DALLAS PARK AND RECREATION DEPARTMENT ADMINISTRATIVE OFFICES

NO	ISSUE	DATE
1	ASI #1	10/09/18

FLOOR PLAN LEVELS 1 & 2

A-201

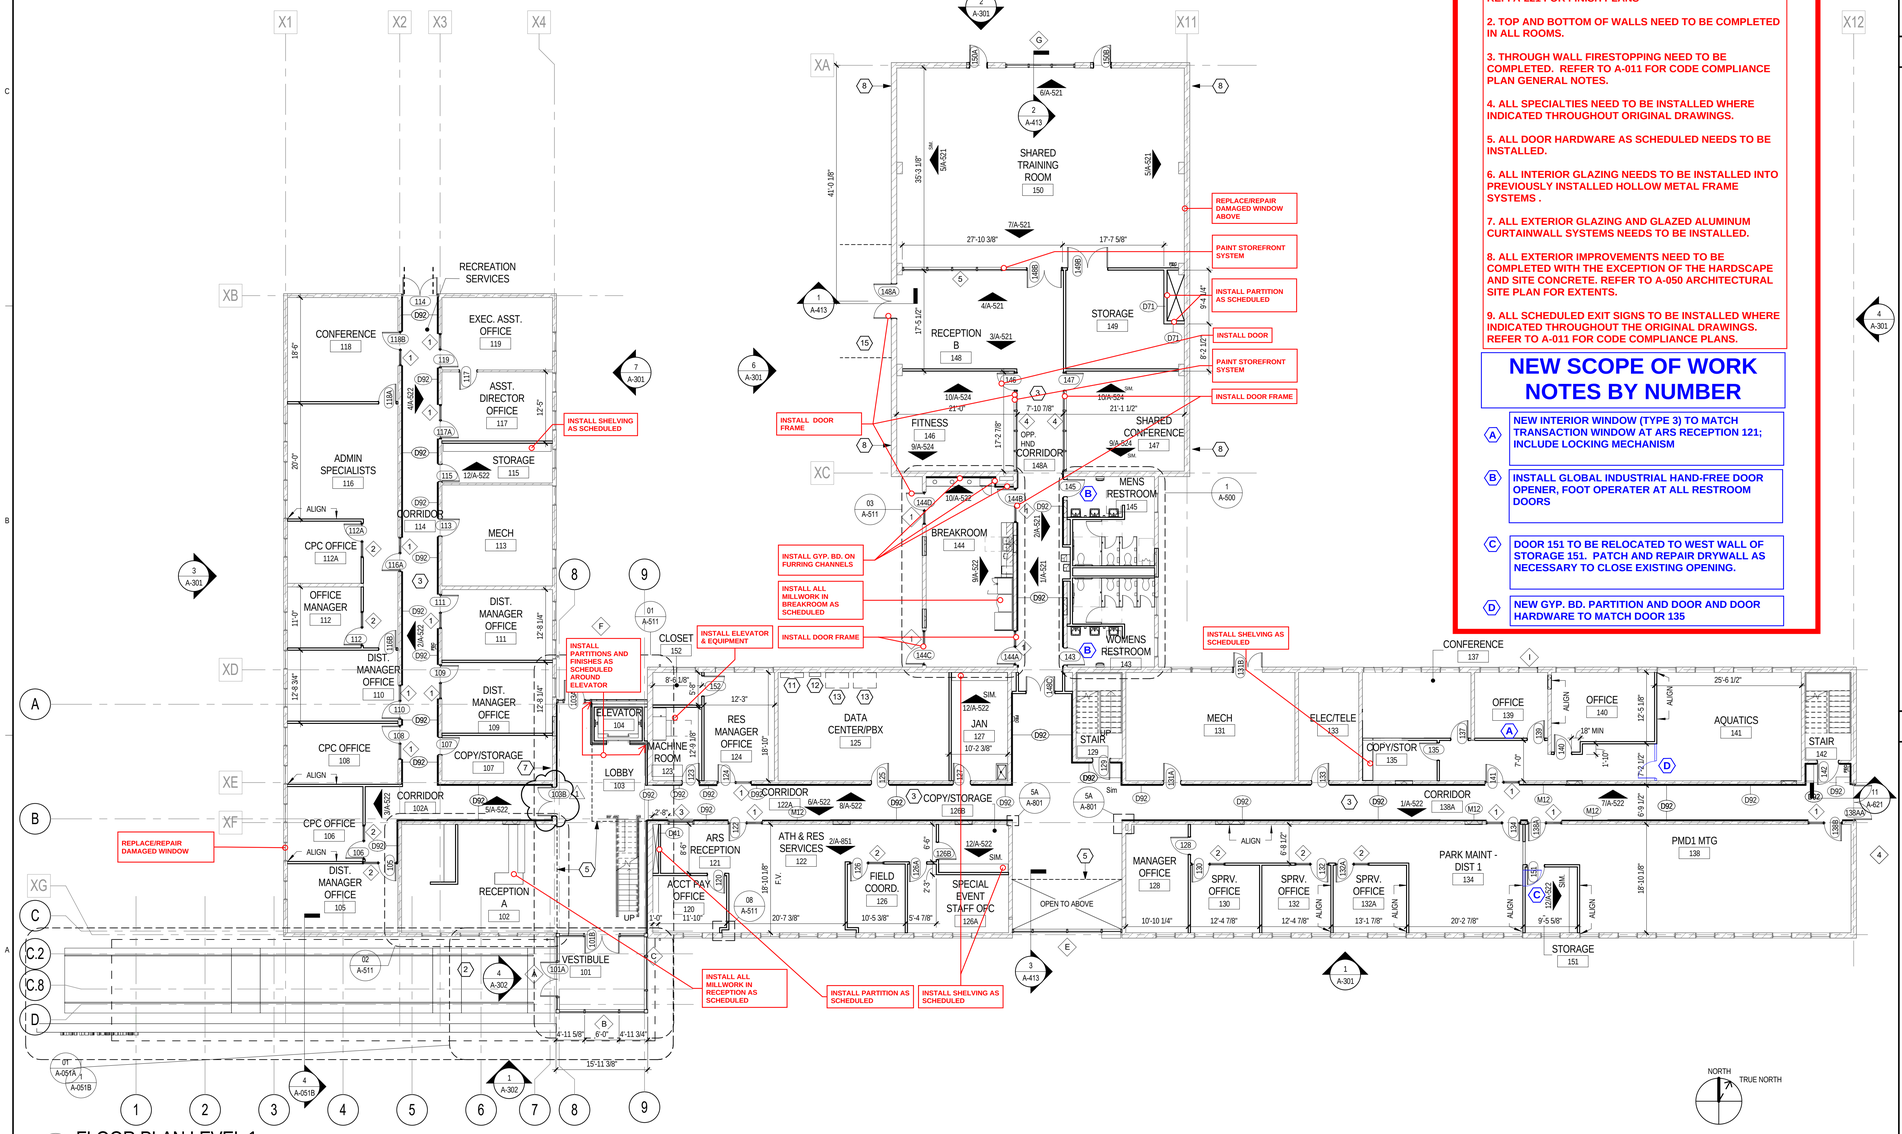
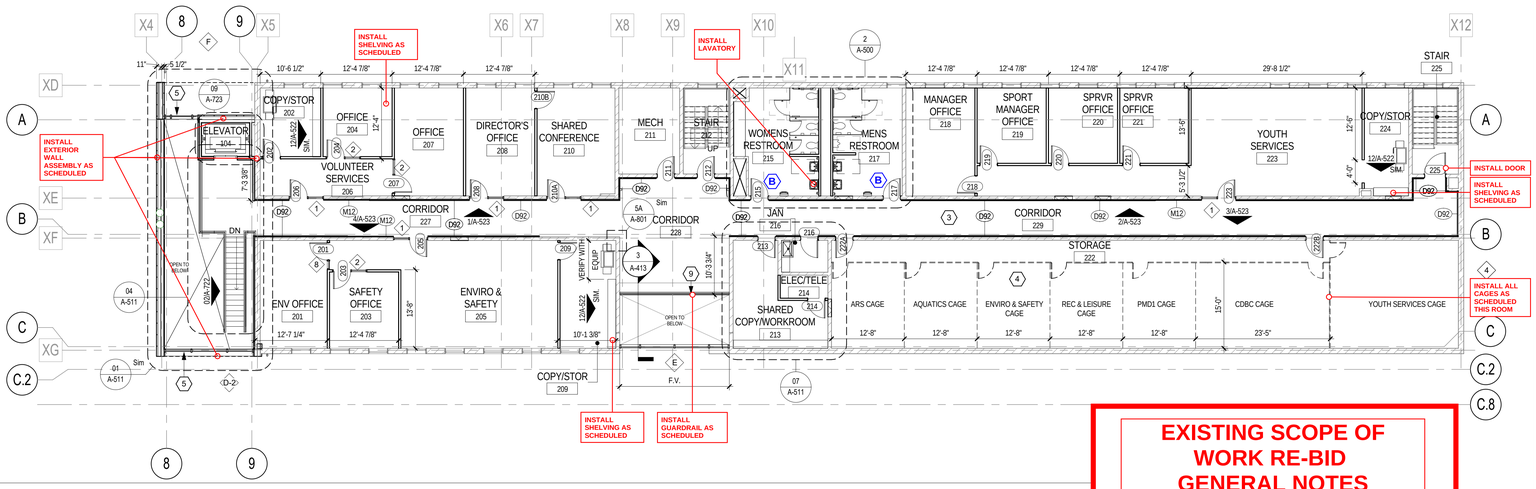
- (A) NEW INTERIOR WINDOW (TYPE 3) TO MATCH TRANSACTION WINDOW AT ARS RECEPTION 121; INCLUDE LOCKING MECHANISM
- (B) INSTALL GLOBAL INDUSTRIAL HAND-FREE DOOR OPENER, FOOT OPERATER AT ALL RESTROOM DOORS
- (C) DOOR 151 TO BE RELOCATED TO WEST WALL OF STORAGE 151. PATCH AND REPAIR DRYWALL AS NECESSARY TO CLOSE EXISTING OPENING.
- (D) NEW GYP. BD. PARTITION AND DOOR AND DOOR HARDWARE TO MATCH DOOR 135
